CENTURY CITY AREA TUNNELING SAFETY AND FAULT INVESTIGATIONS

Tunnel Advisory Panel (TAP)

Los Angeles County Metropolitan Transportation Authority

October 14, 2011

Figure 1: Schematic Cross Section of Santa Monica Fault Zone (from Figure 5, *Century City Area Fault Investigation Report*)

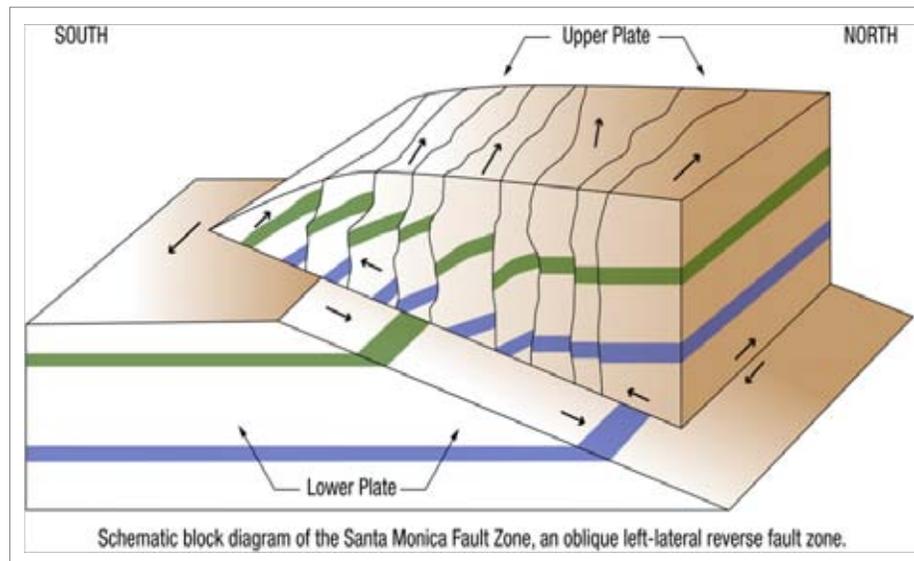
The deformation characteristics of the fault are schematically illustrated by Figure 1, which shows the horizontal displacement and heave and disturbance at and behind the front of such a thrust fault and the displacements on the strike-slip faults.

In summary, the fault investigation has shown that both the Santa Monica Fault Zone and WBHL (i.e., northern extension of the Newport-Inglewood Fault Zone) are active fault zones, and both of the proposed locations for the Santa Monica Boulevard station are within active fault zones. There is no clear evidence for a fault-free section along Santa Monica Boulevard in the vicinity of Century City that is large enough to accommodate a station. Thus it is recommended that proposed station locations along Santa Monica Boulevard no longer be considered acceptable options.

In order to maintain a Century City station alternative on Santa Monica Boulevard, the originally proposed station location was shifted to the east, roughly centered on Century Park East, in an effort to clear the Santa Monica Fault Zone.

Figure 4: Directionally Drilled Borehole along Tunnel Alignment

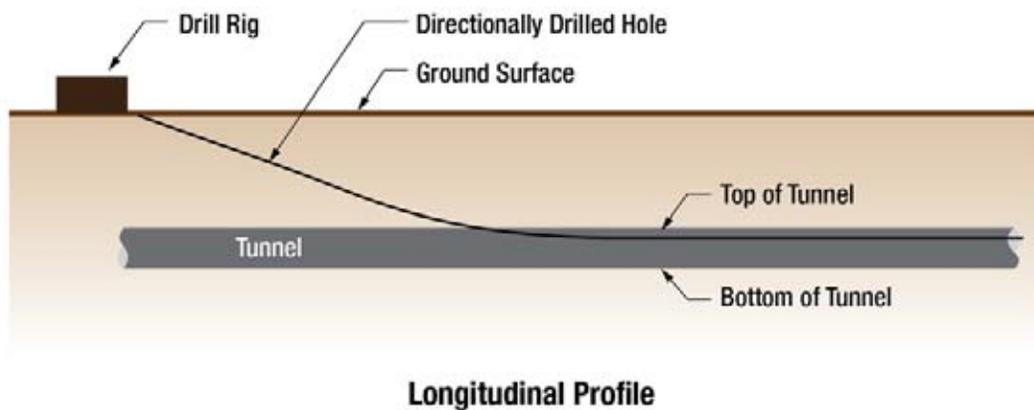
In areas of suspected abandoned wells, probing at the tunnel level is recommended to locate potential well casings before intercepting them in the tunnel. Magnetometer probe holes have been performed on past tunneling projects in Los Angeles. Magnetometer probe holes were extended in front of advancing tunneling machines in selected locations where abandoned wells were suspected to be present. Alternatively, the magnetometer probing can be accomplished prior to tunneling by using horizontal directional drilling (HDD) to extend a boring along the tunnel line into which a probe can be inserted in order to detect any steel casings in the path of the tunnels, as shown in Figure 4. If a well is encountered, procedures for removing the well casing and abandoning the well would be carried out, either prior to tunneling, or ahead of the tunnel face.

6. Conduct magnetometer surveys in probe holes drilled along the tunnel alignment in oil fields where there is the possibility of intersecting well casings, either ahead of the advancing tunnels or prior to tunneling, using horizontal directional drilling. It is recommended that, to the east of the Constellation Station and on the Beverly Hills High School property, the surveys be conducted during the design phase using horizontal directional drill holes.
